June 15th, 1931

Mr. William Randolph Hearst,
137 Riverside Drive,
New York, N. Y.

There is a question on the Neptune Pool needing your decision. The large pool pitches from feet deep at low end to feet at deep end. We agreed to lower the ladies' pool to depth of large pool not thinking of this.

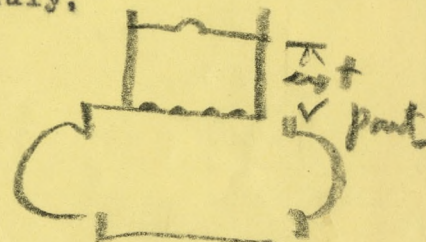
Would you make the new bottom like this in contact at "A", or would you keep the bottom of the ladies' pool up a couple of feet at this point "B"?
